February 24, 1994  
LD-94-015

Docket No. 52-002

Subject: System 80+™ Information for Issue Closure

The attachments to this letter provide revisions to CESSAR-DC and material to close follow-on questions to DSER responses. Attachment 1 provides revisions to the Structural Design Criteria of Appendix 3.8A, which should be given to Mr. G. Bagchi.

FIG 9.1-3 AMENDMENT 5  
E-ALWR-310-140 REV 04

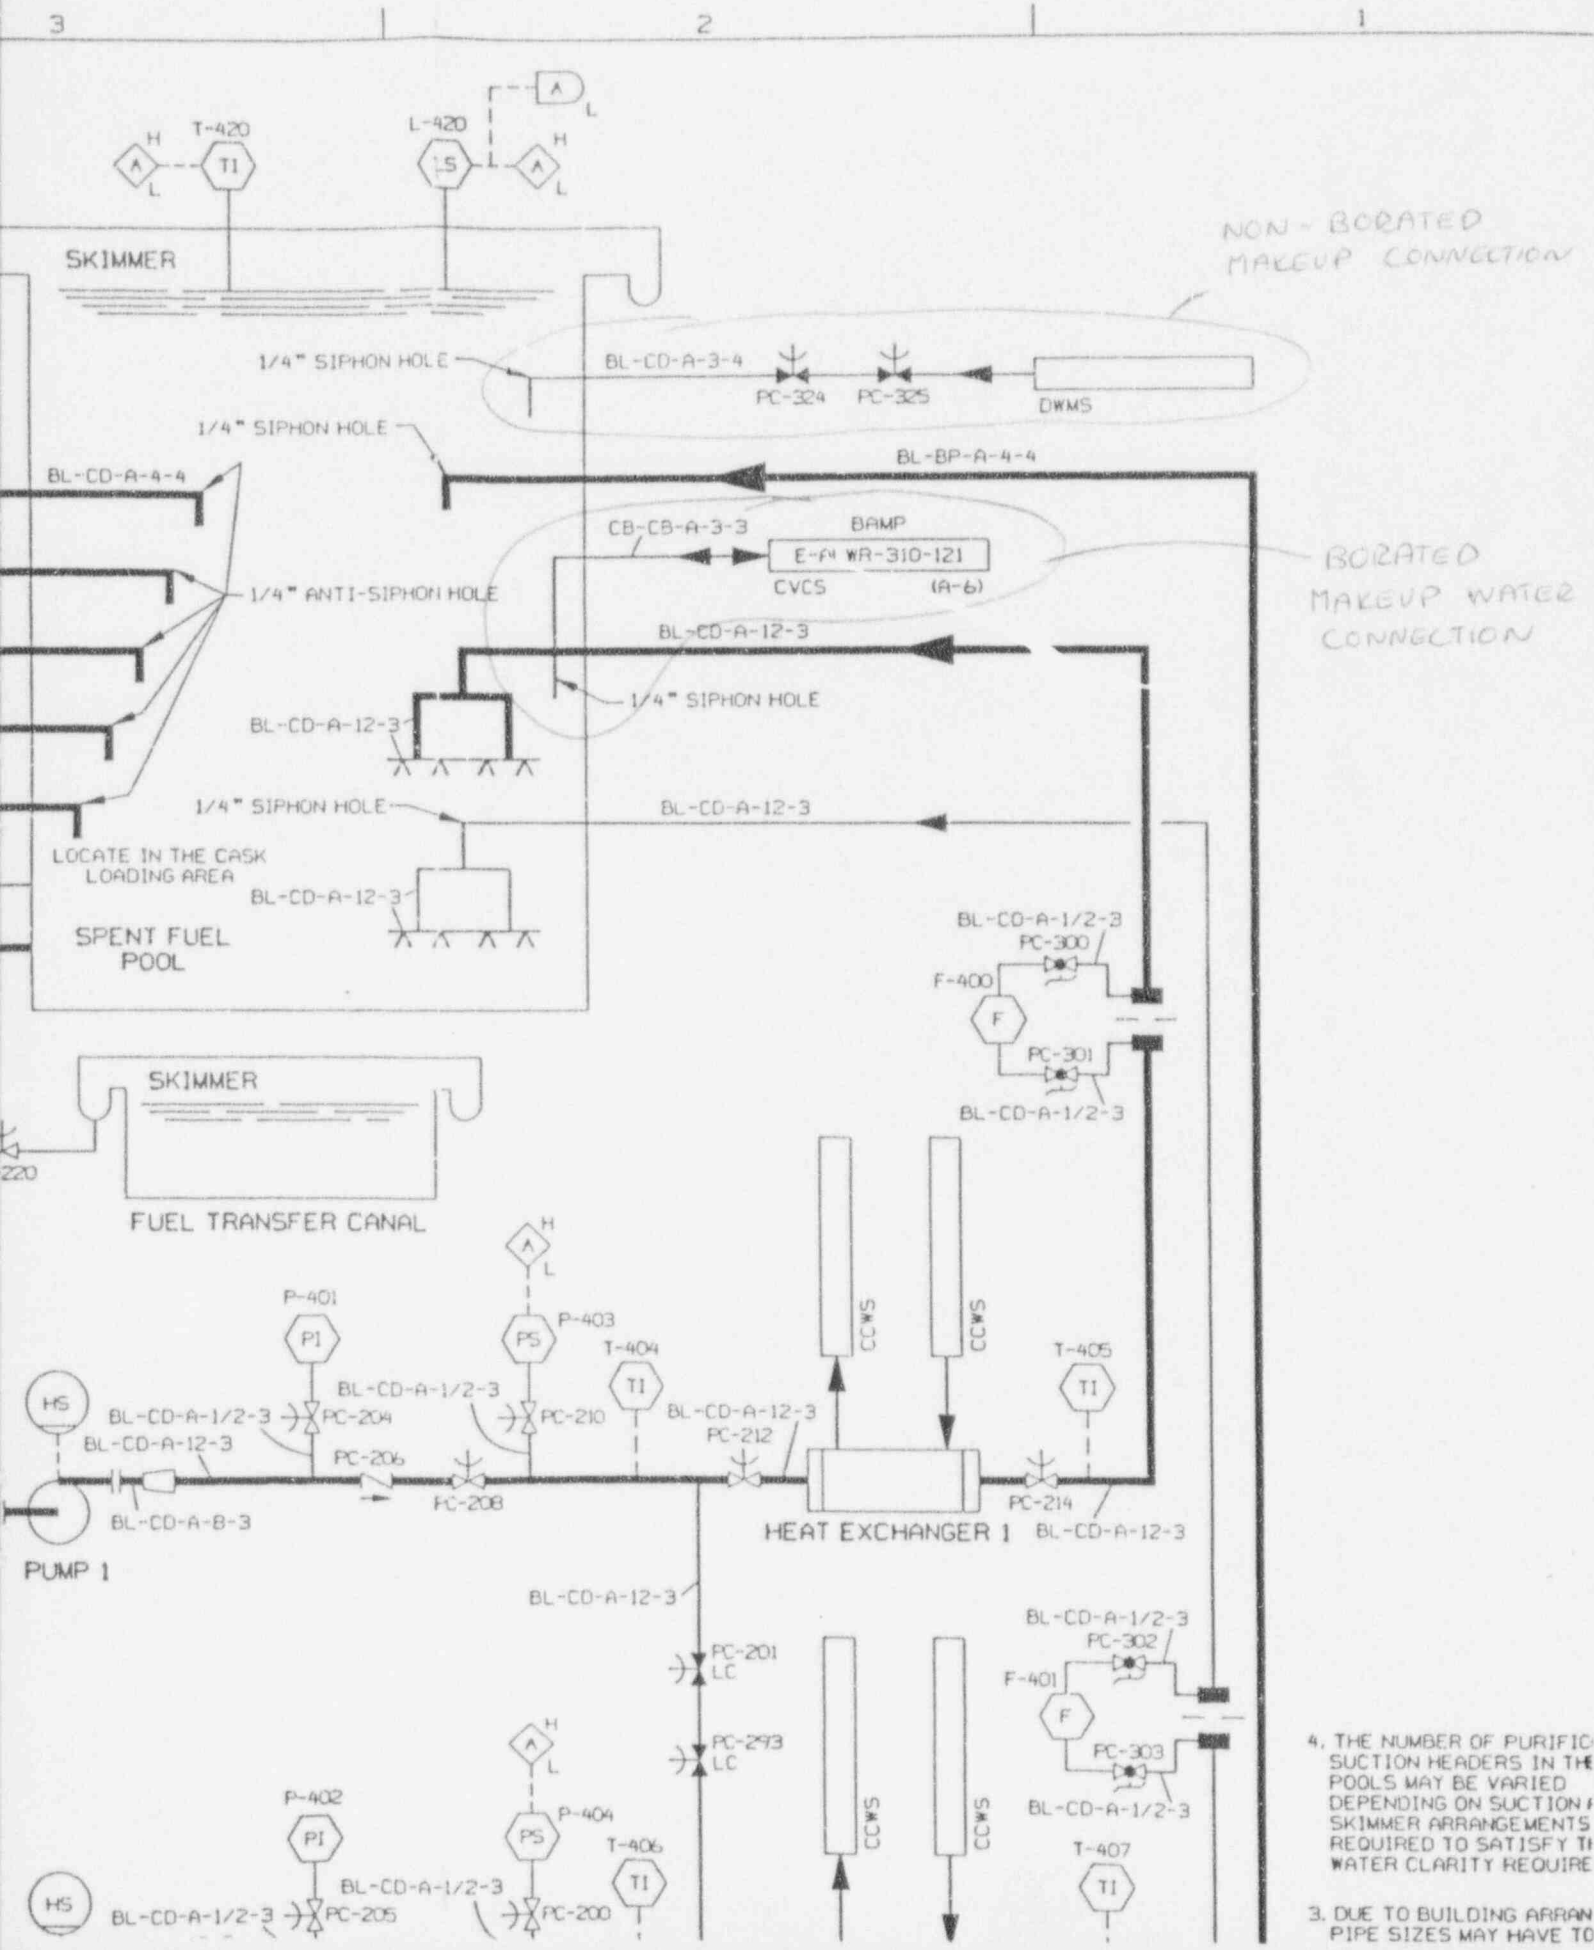
Attachment 4 provides revisions to Section 9.1 recently requested by NRC and a notation (not a revision) to Figure 9.1-3 to show connections for the borated and non-borated makeup water connections.

NON-BORATED  
MAKEUP CONNECTION
